10/811,700

Joerg Weshendorff

<b>Office Action Summary</b>	Application No. 10/811,700	Applicant(s) WESHENDORFF, JOERG	
	Examiner Joselynn Y. Sliteris	Art Unit 3616

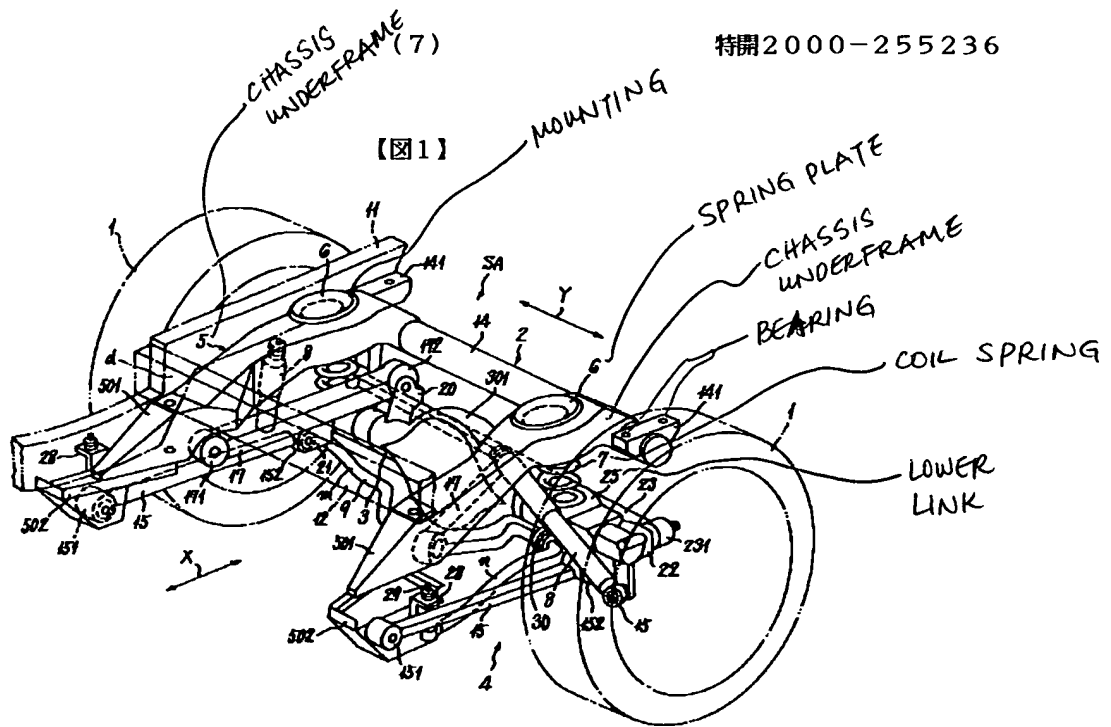
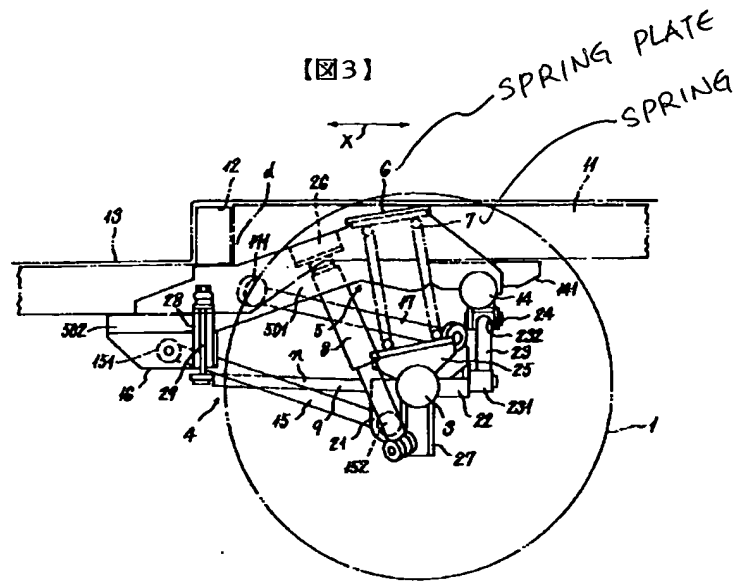
9. Regarding claims 1, 2, and 8, Nagai discloses a wheel suspension system as in the present invention, comprising:

a lower link 25;

a chassis underframe 5 having at least one pair of bearings (see annotated Figs.

1 & 3); and

a spring 7 having a lower end and an upper end, the lower end of which is arranged on the link and the upper end of which is arranged in a spring plate 6;

wherein the chassis underframe has a mounting;

wherein the mounting annularly surrounds the spring plate;

wherein the lower link is designed as a transverse link;
